REVIEW SHEET SUMMARY

FILE # 125-78

ITEM DEV. IN H.O. - BURGER KING

Subdivision Dev. in. H.O. - Burger King # 3

DATE 12-4-78  
DRAWN BY D. SINDLER CHECKED BY H.A.M.P.  
RESTAURANT FOR:  
JACK LEE MEYER  
PROFESSIONAL ENGINEER  
A-3282 L 50+ CAR PARKING

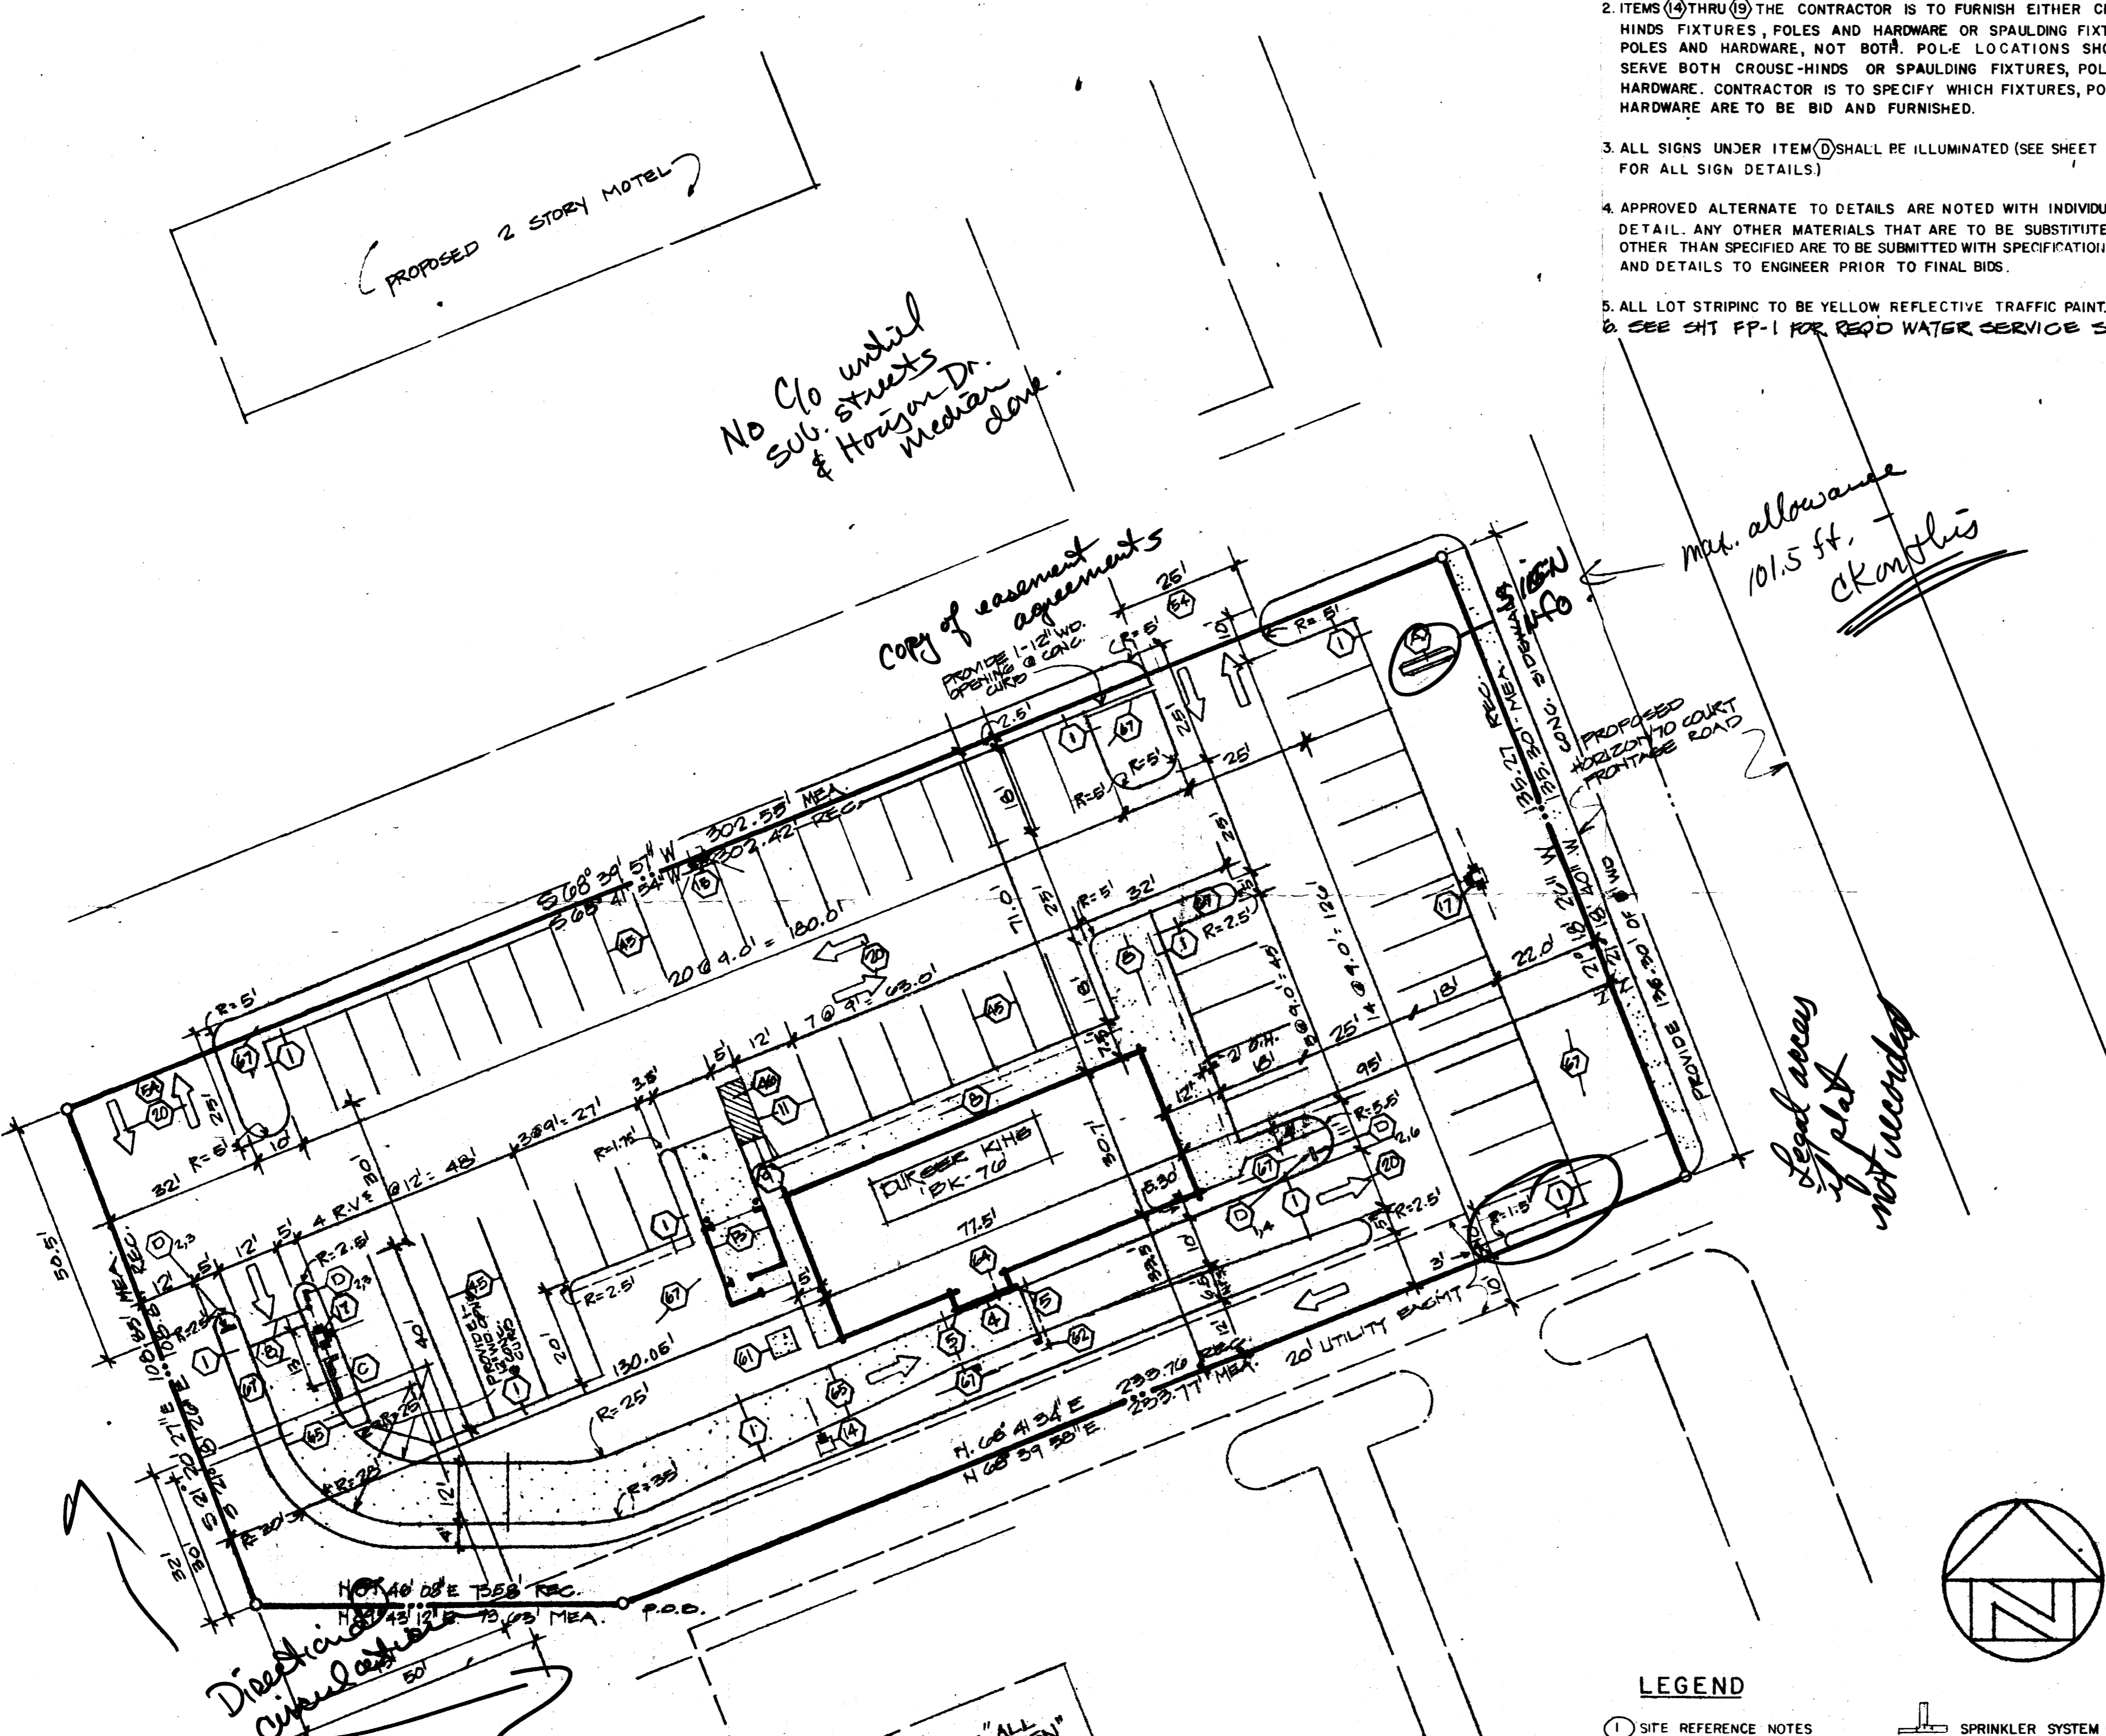
<u>DATE REC.</u>	<u>COMMENTS</u>	
12-12-78	CITY ENG.-RISH	(1) I don't understand the labeled "5' conc. walk (by us)" on s. side of frontage road. That side-walk is part of the public street and is to be constructed with the street and under the Developer's (Treece) Engineer's (Coburn) direct control. Piece-meal construction and/or responsibility on the public works improvements will not be permitted. Please explain to them how this works.  (2) Need some indication on site plan of how site drainage will be routed to the public drainage system (i.e. the street).  (3) Drive-thru seems logical with good stacking length.
12-12-78	MCKEE	Traffic circulation acceptable.
12-8-78	FIRE DEPT.	To meet required fire flow, a hydrant must be added along frontage road on North corner, minimum 8" diameter line.
12-29-78	MOUNTAIN BELL	No objections.
12-20-78	PUBLIC SERVICE	Electric: require easement to transformer location. Gas: no objections.

1-19-79	PARKS & RECREATION	I hope their elevations are 4700 and not 4200 as written. A 500' hole is not needed.
1-19-79	POLICE DEPARTMENT	Approved.
1-19-79	PUBLIC SERVICE	Gas: No objections Electric: Padmount Transformer to be located south of trash-bin and west of building
1-19-79	CITY UTILITIES	No comment. Need more detail on trash and sewer including proposed pick up point and access to pick up point.
1-19-79	FIRE DEPARTMENT	OK- submit plan of water supply for fire protection (line sizes and hydrant locations) for approval.
1-22-79	MOUNTAIN BELL	Utility easements satisfactory as shown.
1-22-79	CITY ENG-RISH	1- As instructed by Luther Musgrove on Nov. 2, 1978, I am holding up on review approval of construction plans for Horizon Circle until they submit revised details for Horizon Drive intersection. 2- Subdivision developer is responsible for completing construction of Horizon Circle and Horizon Drive median changes prior to opening of All the Kings Restaurant and Burger King. They agreed to this as "Phase I" for subdivision. 3- This grading plan shows west 1/3 of site draining to the Northwest corner. How will this runoff be routed to the storm drain system which is in Horizon Circle on the east edge of the site? 4- I assume their grading plan fits the developers planned grade for Horizon Circle.

*need landscape info.*  
*File copy*  
*BK*
